From: Emma Thompson
Sent: 05 September 2018 14:00
To: Emma Thompson
Subject: FW: 2018/91283 - 9 Far Bank, Shelley.

From: Hamish Gledhill [<mailto:hamish@acumenarchitects.co.uk>]
Sent: 31 July 2018 08:48
To: Emma Thompson <Emma.Thompson@kirklees.gov.uk>
Subject: RE: 2018/91283 - 9 Far Bank, Shelley.

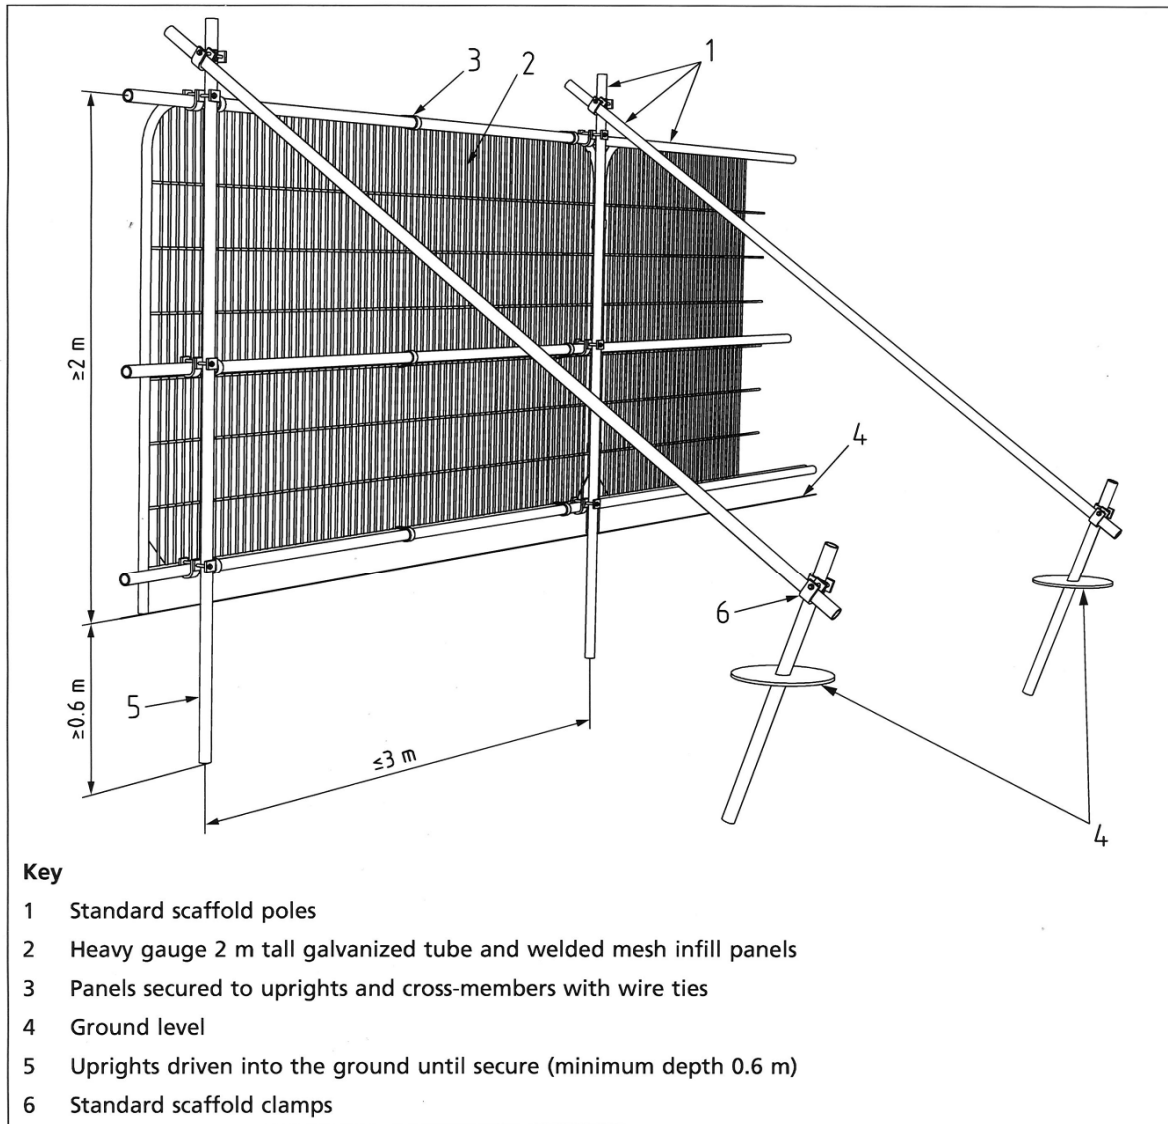
The trees to the south of the proposed development are separated from the site by a culvert, which is shown on the proposed site plan. The culvert provides a physical barrier which will prevent the works encroaching on the root protection area.

A tree protection barrier will be installed along the northern edge of the culvert up to the point where the culvert crosses the proposed site boundary. At this point the protection barrier will run to the south western corner of the existing dwelling at 9 Far Bank.

The protective barrier will be installed in accordance with BS5837: 2012. The default specification of BS 5837: 2012 (pictured below for reference) recommends a vertical and horizontal, scaffold framework, well braced to resist impacts, with vertical tubes at no more than 3m intervals. These should be driven into the ground. Weld mesh panels should be affixed to this framework with scaffold clamps.
